Westinghouse
Electric Corporation

DCP/NRC1067
NSD-NRC-97-5363
Docket No.: 52-003

SUBJECT: REVISED DRAFT AP600 PRA ATTACHMENT 54B - SURGE LINE FLOODING
EFFECT ON SHUTDOWN PRA

SURGE LINE FLOODING EFFECT ON LOW-POWER AND SHUTDOWN RISK ASSESSMENT

Figure 4-200-202
54-B-1

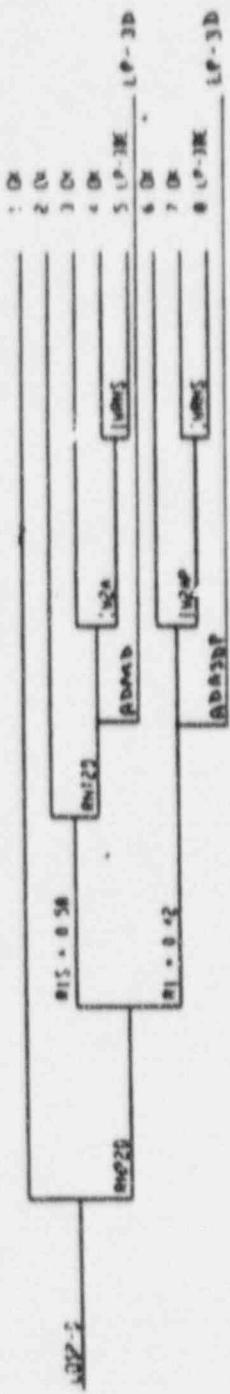
- a. Include ADS stage 4 in the shutdown event trees for drained conditions. The revised event trees are provided in Figures 54B-1 through 54B-5.
- b. Construct two ADS fault trees: ADASD for cases with offsite power available, and ADASDP for the station blackout case. The success criteria summary tables for these fault trees are provided in Tables 54B-1 and 54B-2.
- c. Construct ADS support system fault trees for the fault trees developed in item b.
- d. Construct initiating event sequences for the reduced inventory cases to include ADS success or failure, as appropriate. These sequences used the fault trees for the IRWST, RNS, CCS, and SWS that are reported in the shutdown PRA, Revision 6, without modification.
